Response to Submissions

Prepared for: **Grand Noble Project 1 Pty Ltd**

The State Significant Development Application (SSD-96272465) for residential development with in-fill affordable housing at 11–23 Rangers Avenue, Mosman was publicly exhibited between 4 December 2025 and 17 December 2025. During the exhibition period, a total of 185 submissions were received.

Figure 2 Deep Soil Diagram

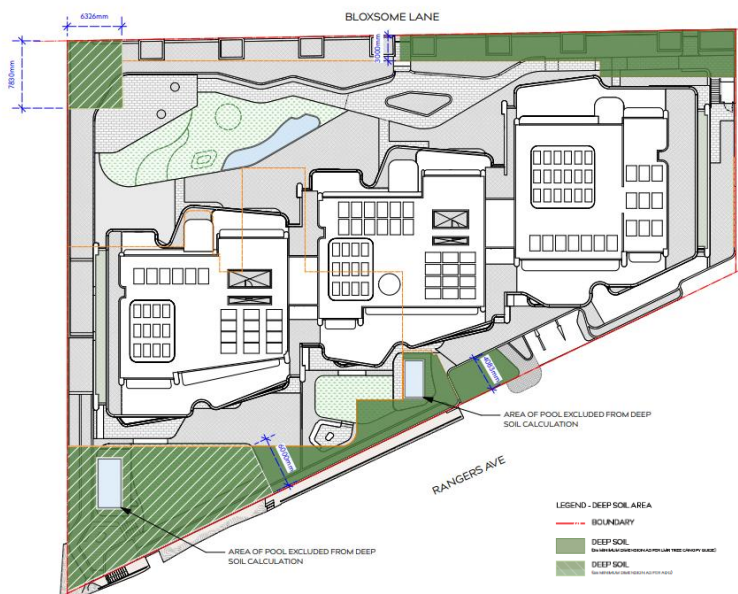
In response to DPHI concerns regarding basement setbacks and compromised deep soil zones, the basement footprint has been rationalised and reduced, particularly along the northern boundary.

- A 3 m basement setback to the north, enabling a continuous deep soil zone.
- Reconfiguration of basement layout, including adjustments to parking and circulation.
- Refinement of the affordable housing and BTS lobby arrangements.
- Provision of deep soil zones capable of supporting mature tree planting in accordance with the ADG and LMR Tree Canopy Guidelines.

As demonstrated in the Deep Soil Calculations and Landscape Area Diagrams, the proposal now provides 8.1% deep soil under the ADG and 16.2% under the LMR controls, exceeding requirements.

Figure 4 Updated Landscape plan showing substantial tree planting to the north and western boundary at Level 1

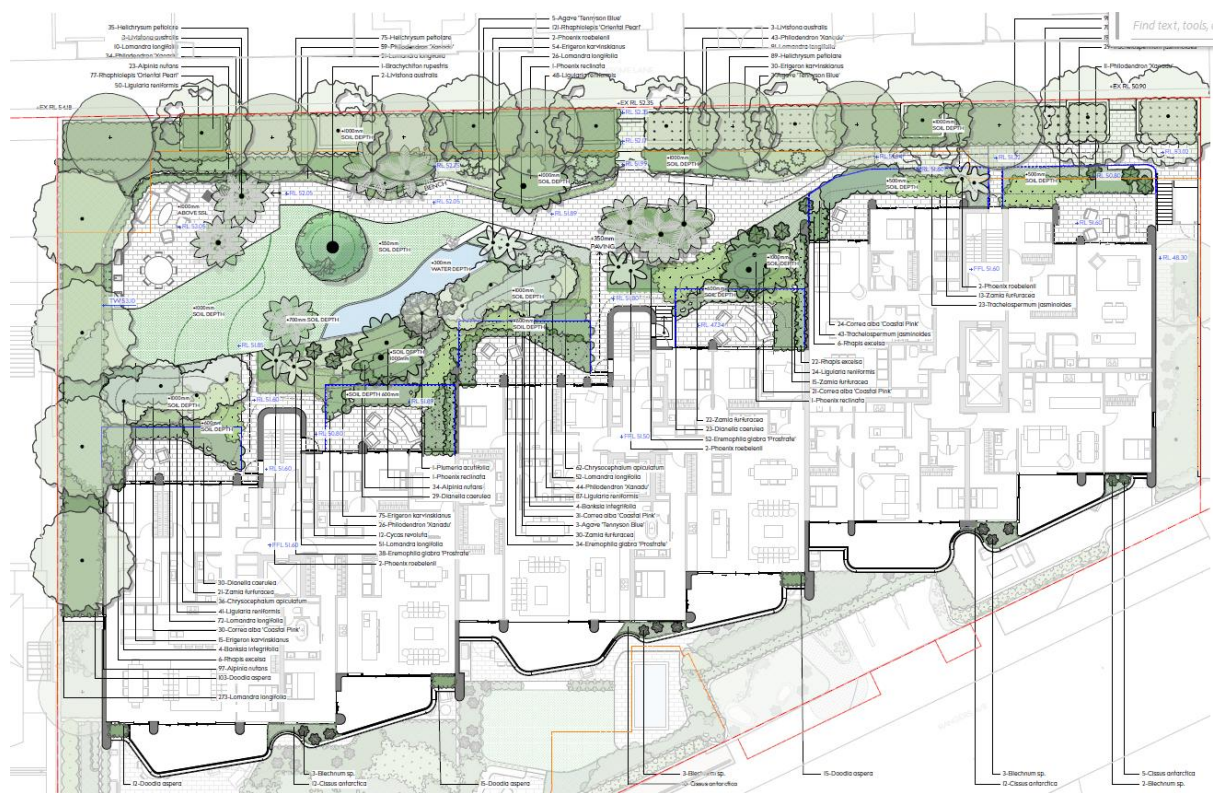
- Raises landscaping and tree canopy matters, including recalculation of deep soil per ADG definition, confirmation of 30% landscaped area, and additional planting/soil volume details.

- Provision of new deep soil zones along the northern boundary, including two zones to the north-east and north-west corners of the site, designed to support large-canopy trees at maturity.
- Substantial deep soil planting along the Rangers Avenue frontage, reinforcing the landscaped streetscape character.
- Soil depths, soil volumes and species selection coordinated with the LMR Tree Canopy Guidelines to ensure trees can achieve their intended size and canopy spread.

The revised basement setbacks enable deep soil areas of sufficient width and depth, as illustrated in the Soil Depth and Soil Volume Diagrams (SSDA_202 to SSDA_205). This allows for meaningful tree establishment and long-term viability.

Figure 9 Updated Landscape Plans

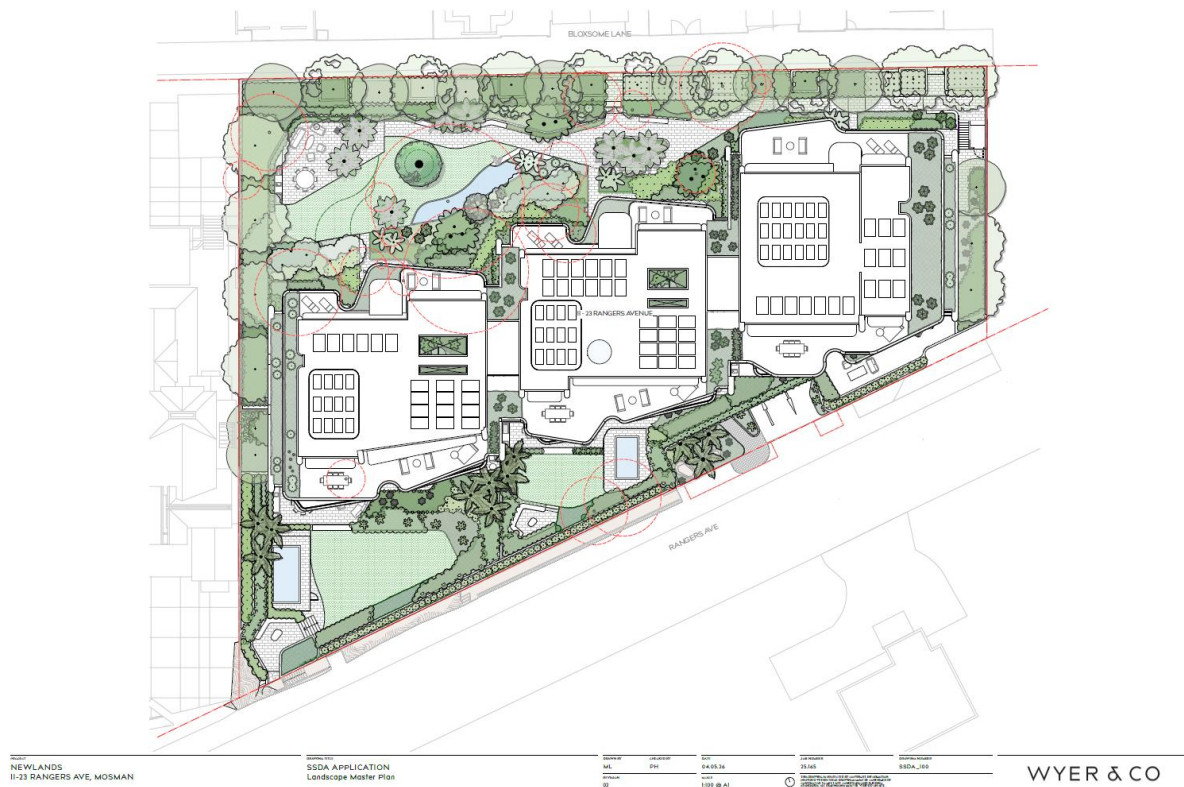
- Raises concerns on deep soil and landscaping outcomes, disputing the applicant’s deep soil calculations and identifying a shortfall against minimum requirements, with limited deep soil along boundaries reducing the opportunity for meaningful canopy trees and screening (noting much landscape is podium planting).

As extracted in the updated Landscaped Plans in **Figure 9** below, the proposal development is heavily landscaped throughout the full site to enhance greenery throughout the site and reduce the impact of the proposal on the surrounding properties. Specifically, the amount of deep soil planting has now significantly increased when compared to the previously submitted proposal, including a deep soil zone of approximately 3m along the northern boundary towards Bloxsome Lane. A line of trees will also be planted along the east, north and western boundaries of the site provide shielding towards the neighbouring properties.
